# **MIPS R4400PC/SC Errata, Processor Revision 2.0 & 3.0**

January 24, 1995

Figure 1a: Power-on Reset or Cold Reset - Workaround for Bug# 16

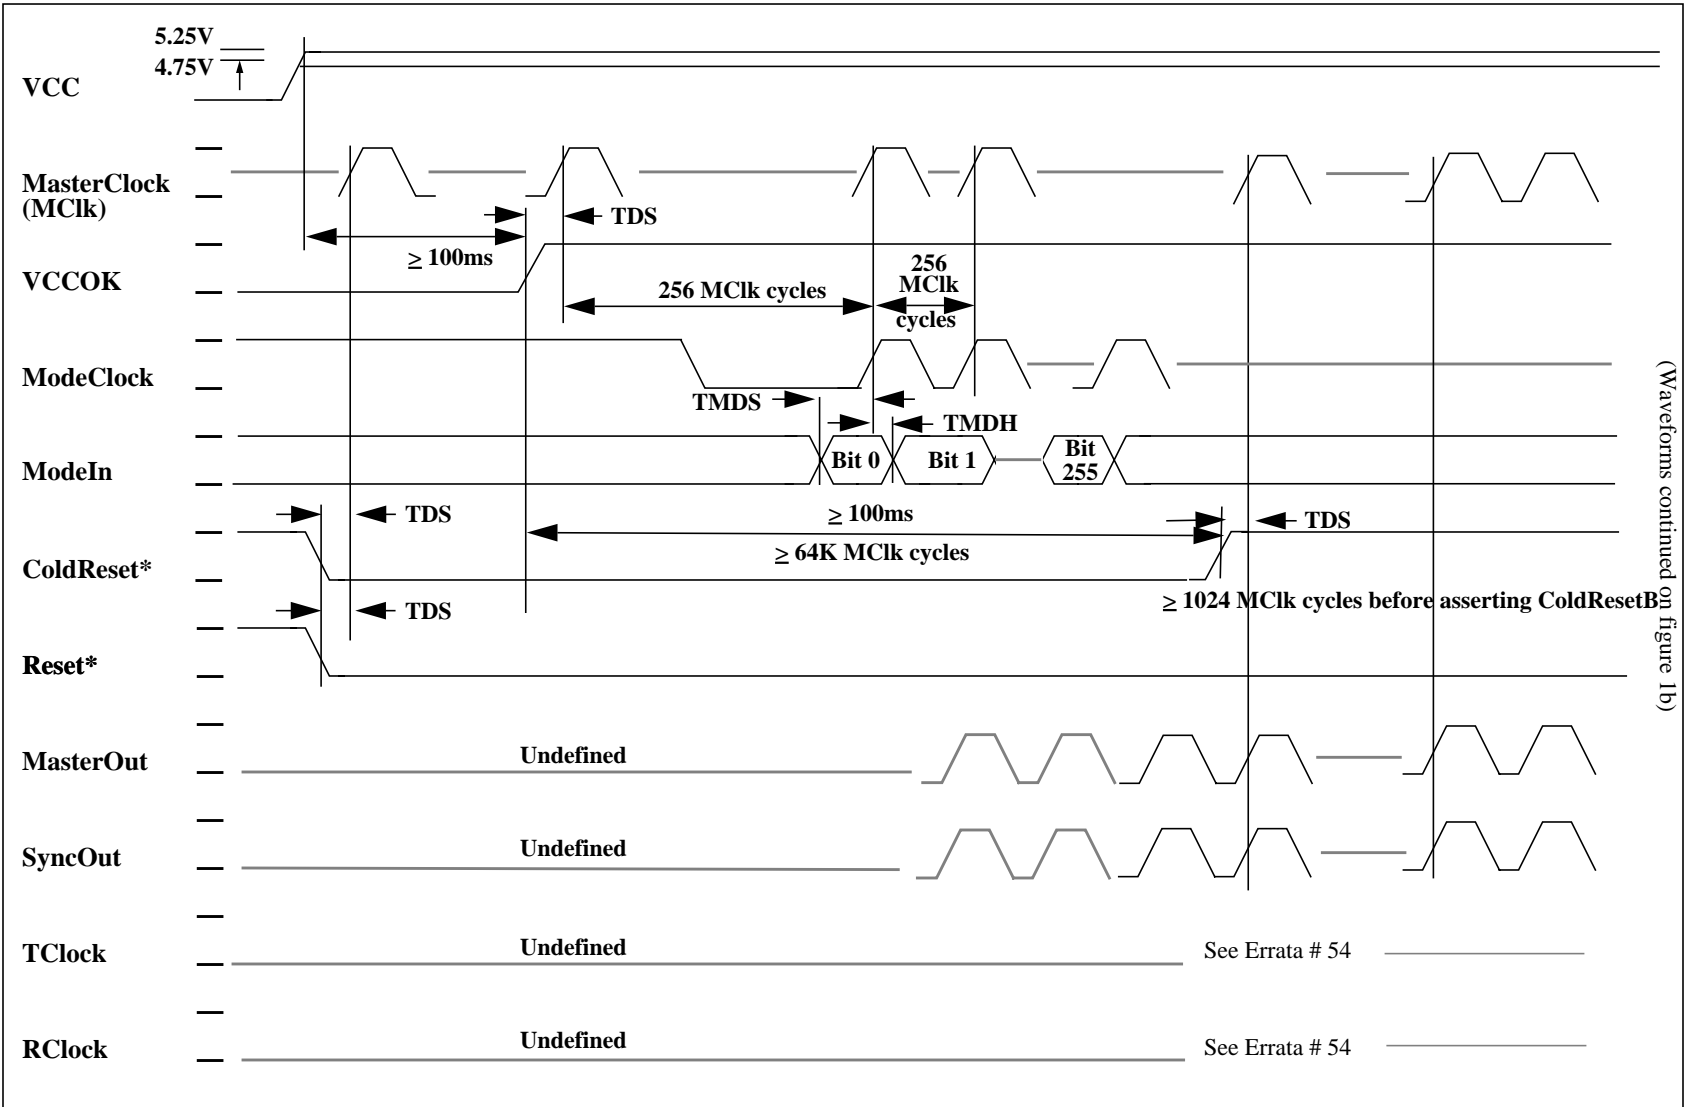
15. R4400PC, R4400SC: During the power up sequence, the period of TClk and RClk may not be as expected for at least 1024 MasterClock cycles following the de-assertion of ColdResetB. The above bug is true for all system interface divisors. Furthermore, if the system interface divisor other than 2 (i.e. 3,4,6 & 8) is used, TClk and RClk's rising edge may not align to the rising edge of the MasterClock, as specified.

Thus, for system with interface divisor set to two, the only violation will be that the TClk and RClk's period might not be valid within 64 MasterClock after the ColdResetB is de-asserted.

**Workaround:** Assert a second ColdResetB after at least 1024 MasterClock cycles from the de-assertion of the first ColdResetB. ResetB should remain asserted until at least 64 MasterClock cycles following the de-assertion of the second ColdResetB. TClk and RClk will then be valid 64 MasterClock cycles after the de-assertion of the second ColdResetB and their edge alignment with respect to MasterClock will be as specified. Figure 1a & 1b show the waveforms in more detail. Note that the waveforms in Figure 1b are continuation of the those in figure 1a.
